Grimes City Council Agenda

Topic: Grimes City Council February 23, 2021

- A. Public Hearing and First Reading of Ordinance 747 Rezoning of Property at SE 19th and James Street
- B. Public Hearing and First Reading of Ordinance 748 2018 Building and Fire Code Adoption
- C. Approval of Site Plan – 1861 SE Princeton Drive

2 STORMTECH SC-740 CHAMBER SYSTEM

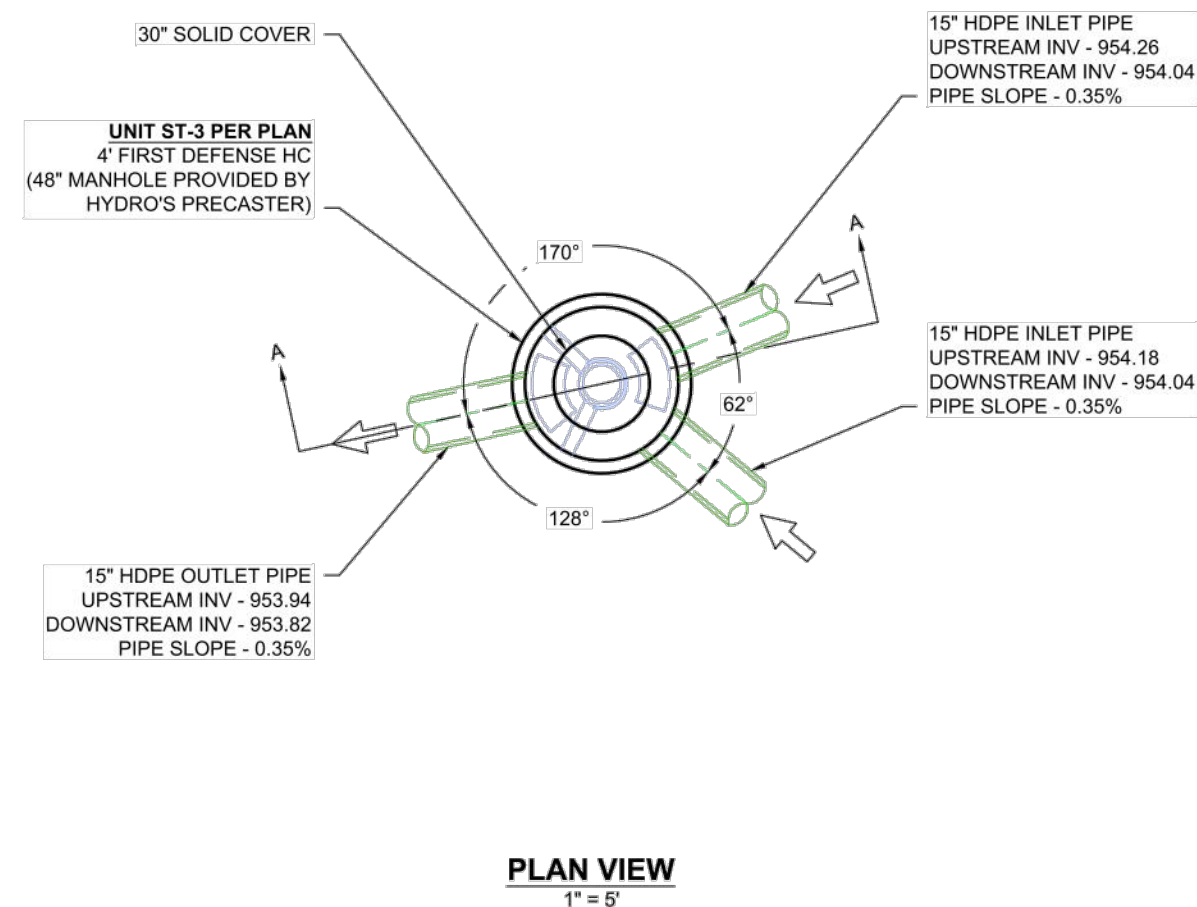
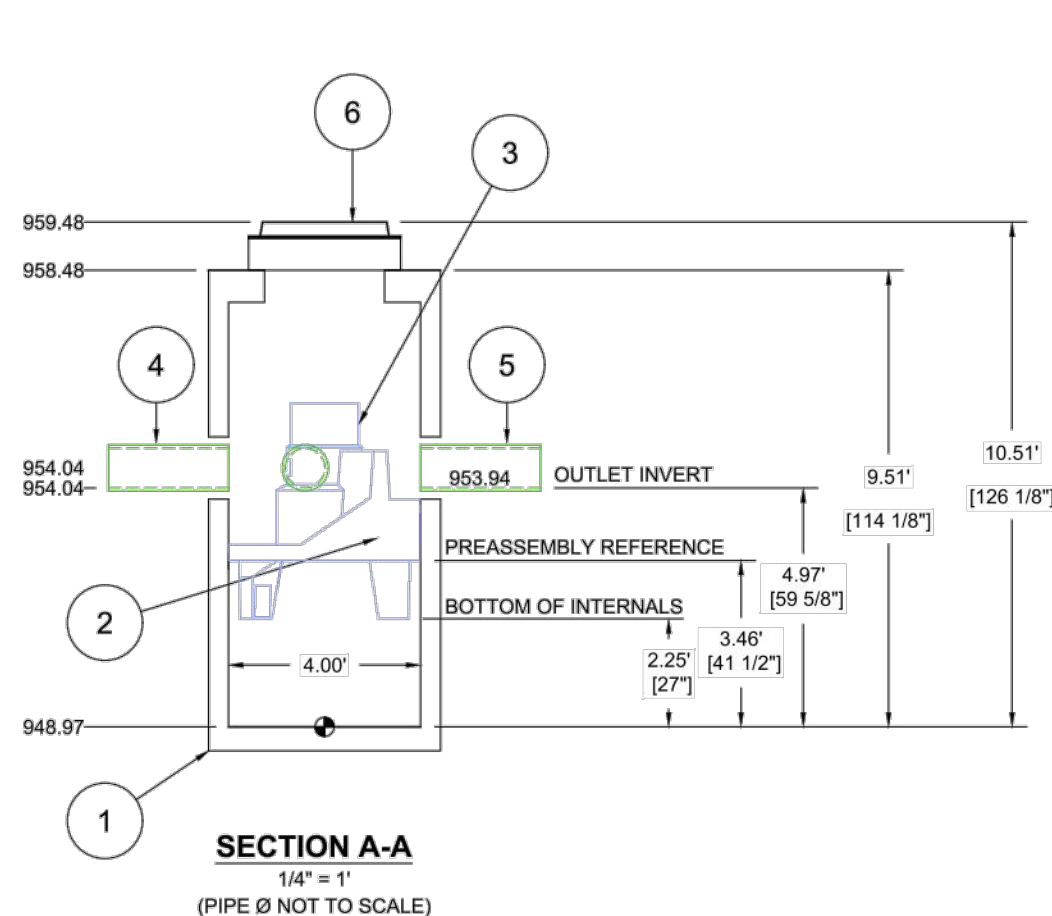
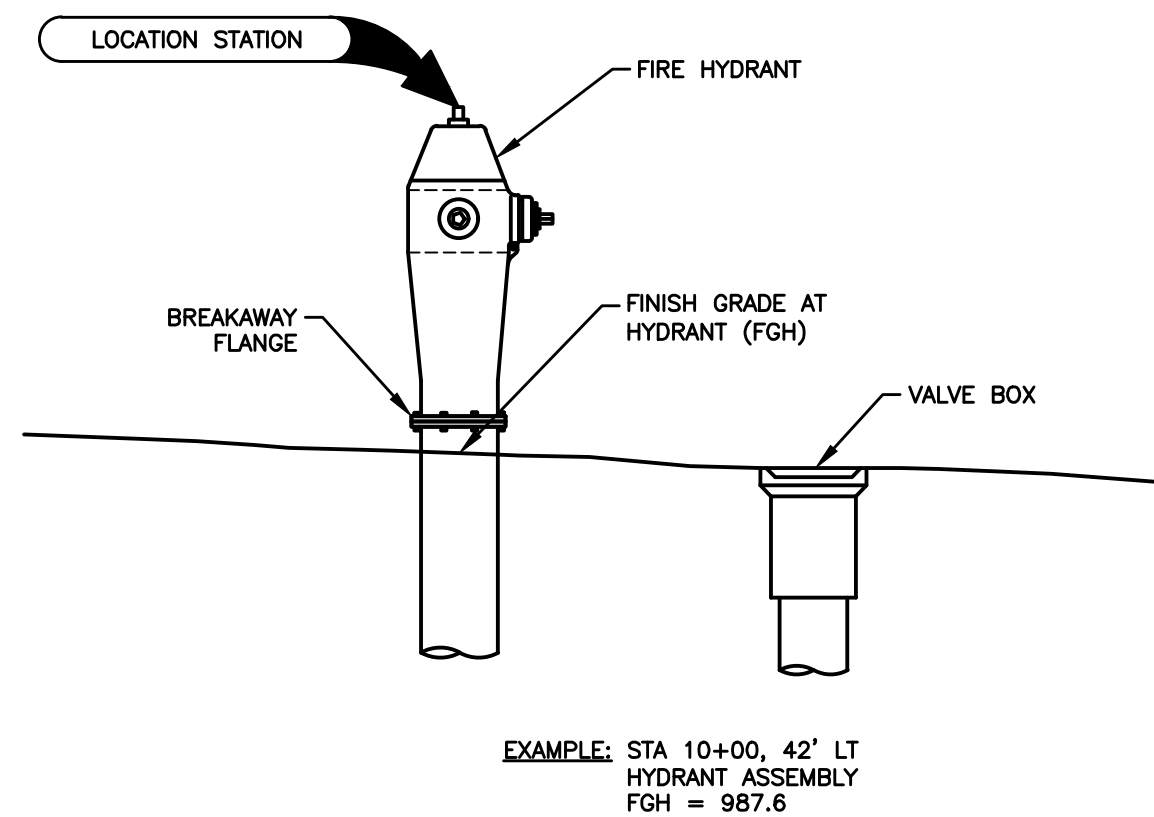
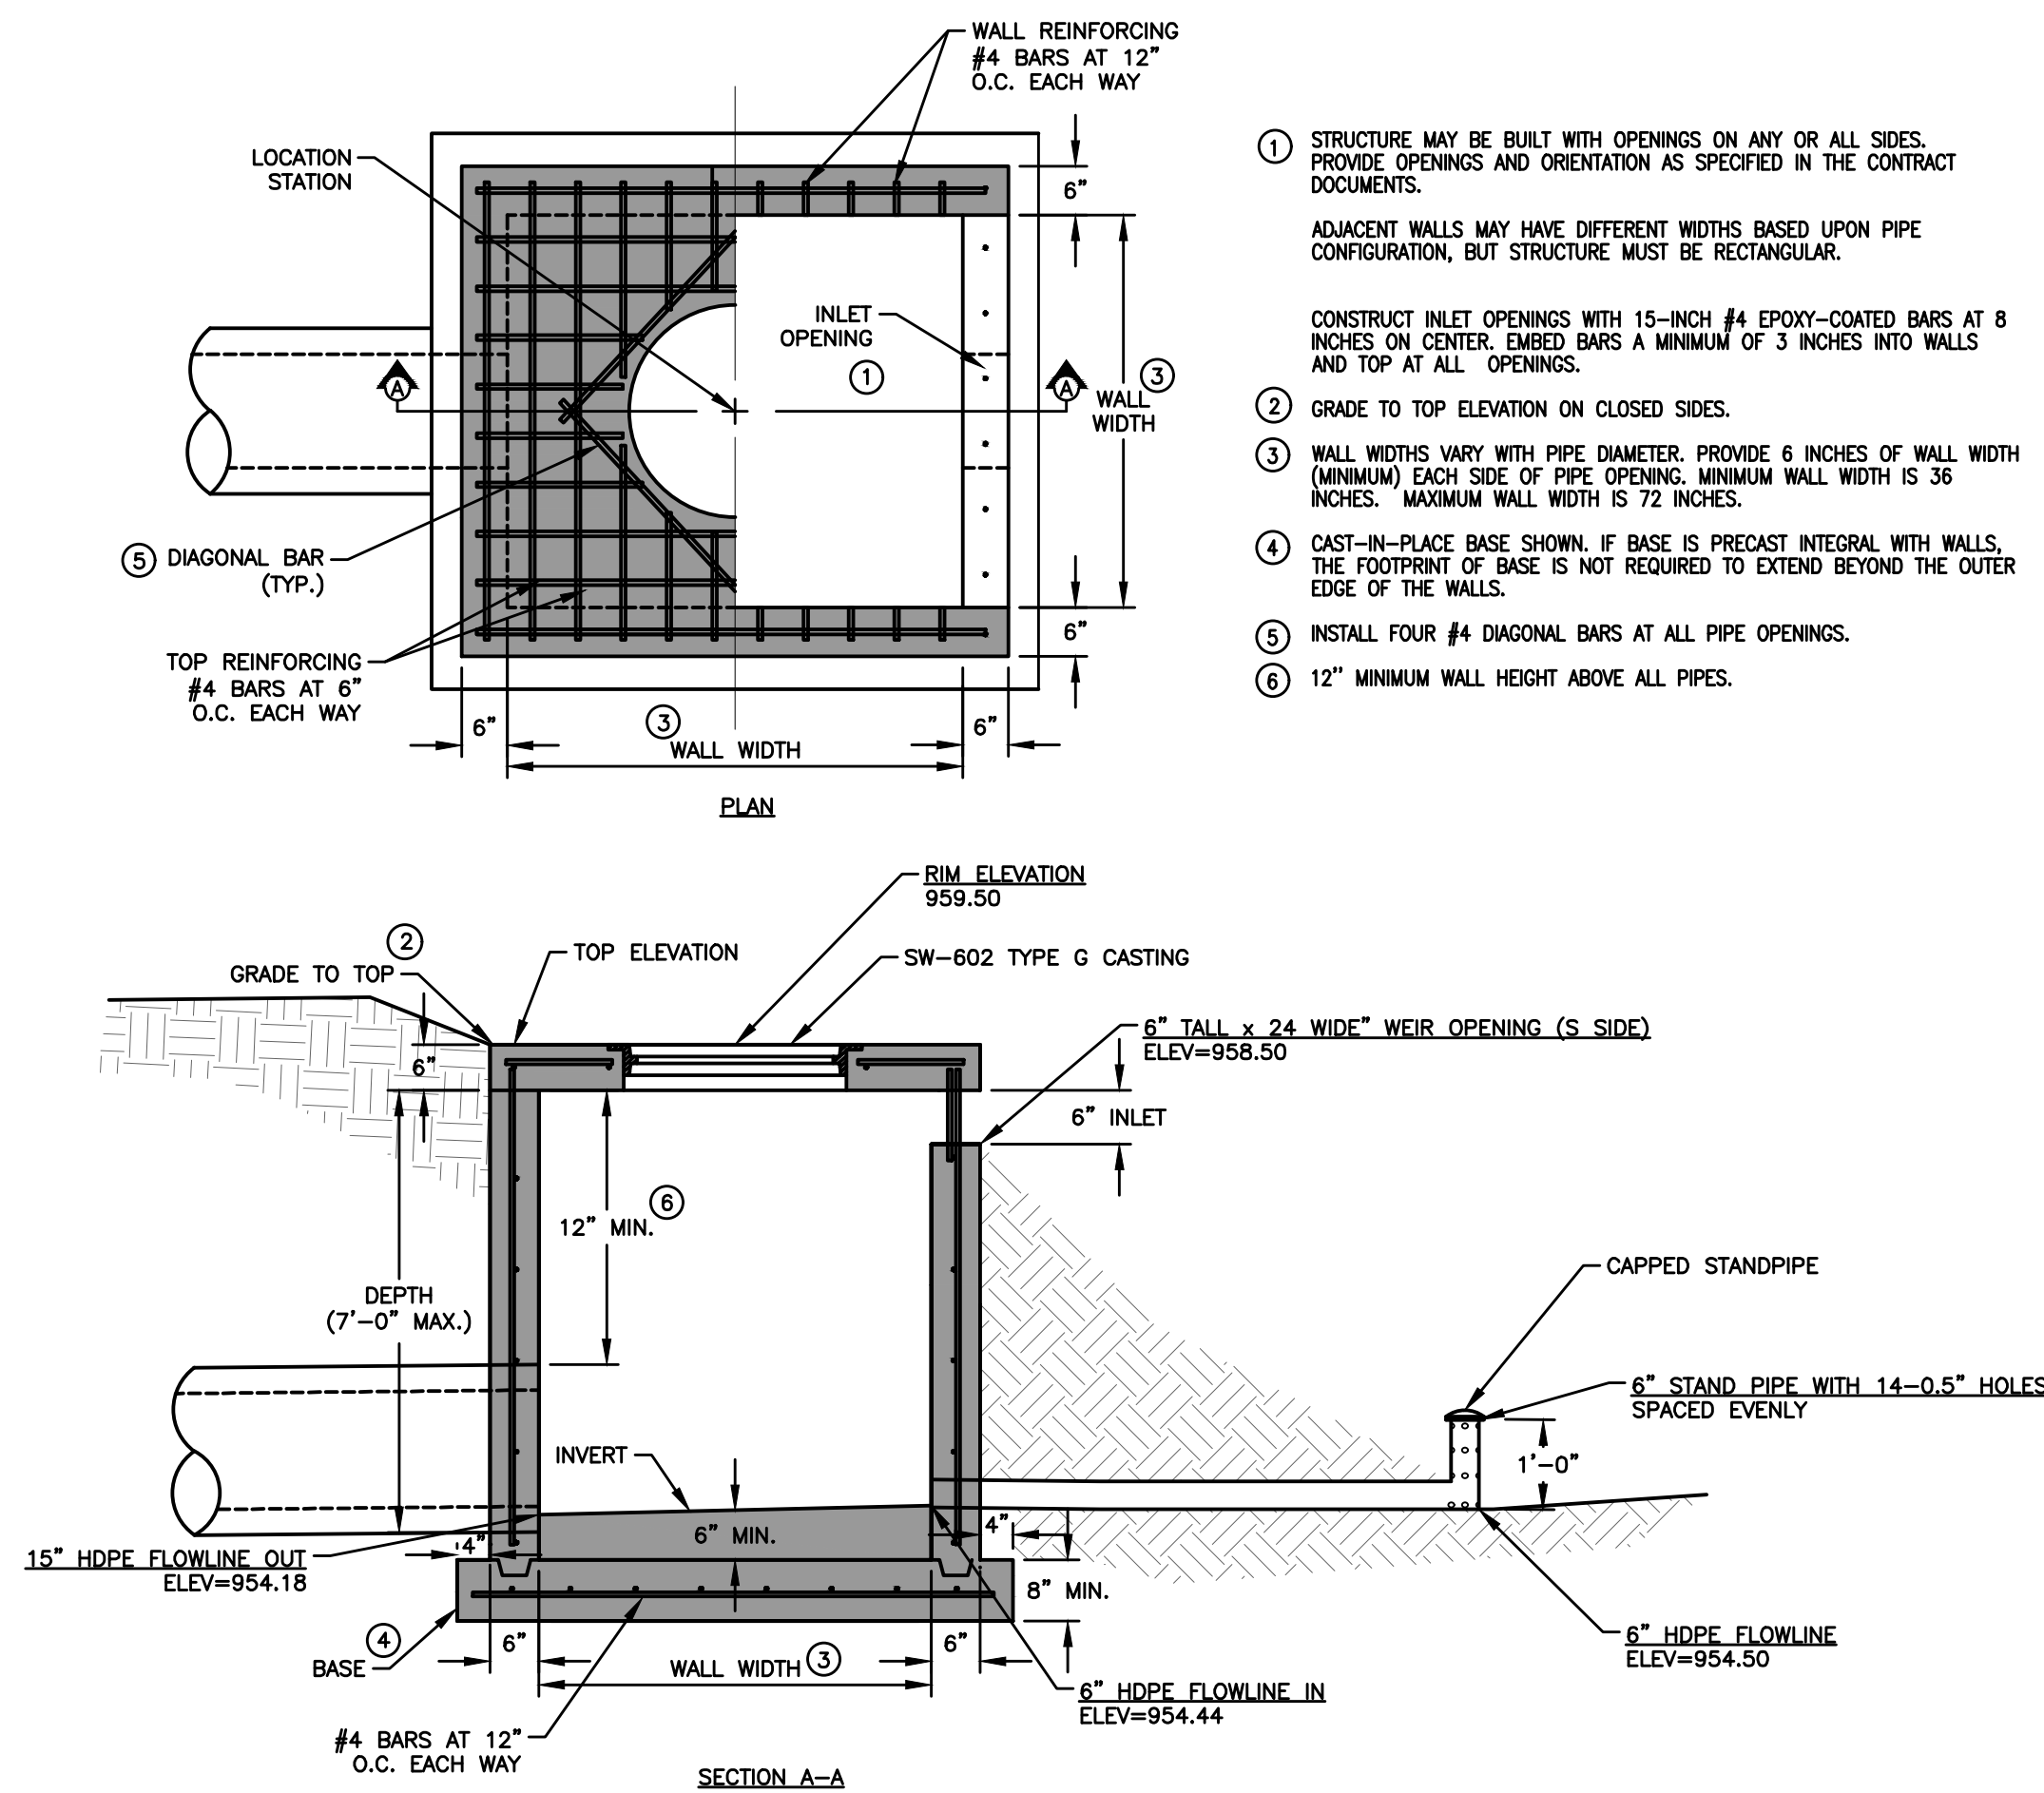
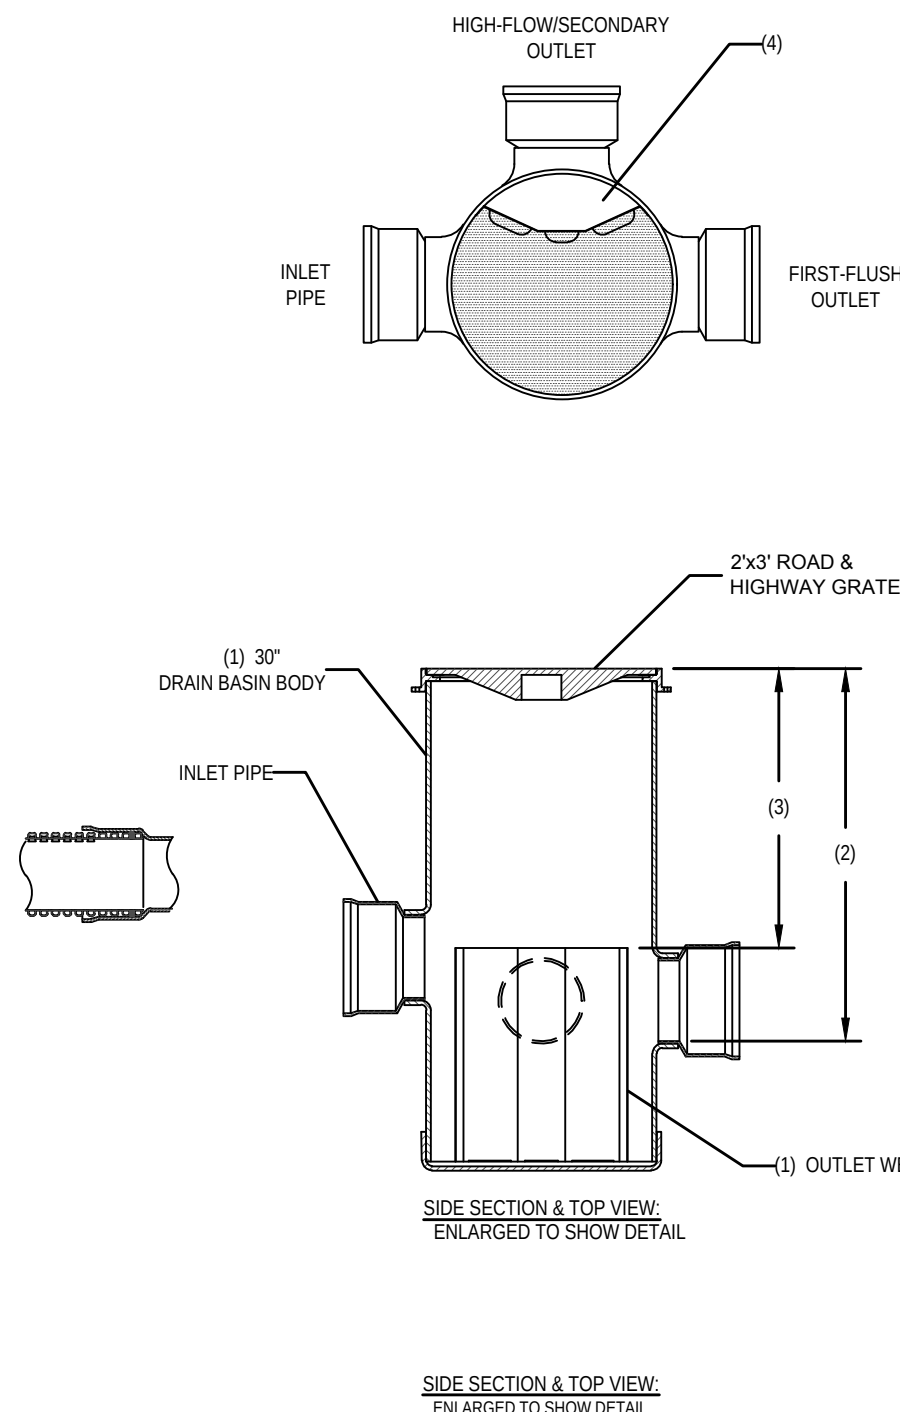
- ~~12. Sheet C5.2: Rename as sheet C5.2.~~

~~13. Sheet C5.2: Details shown are just typical. Please provide specific details for this design. Size of chambers, isolator row, what is the perforated line on the west side of the chambers (if this is an underdrain, what size is it, and is it below the chamber systems at ele. 954.51, and is it below the outlet pipe ele. 954.36), depth of rock above and below chambers, are there any inspection ports.....~~
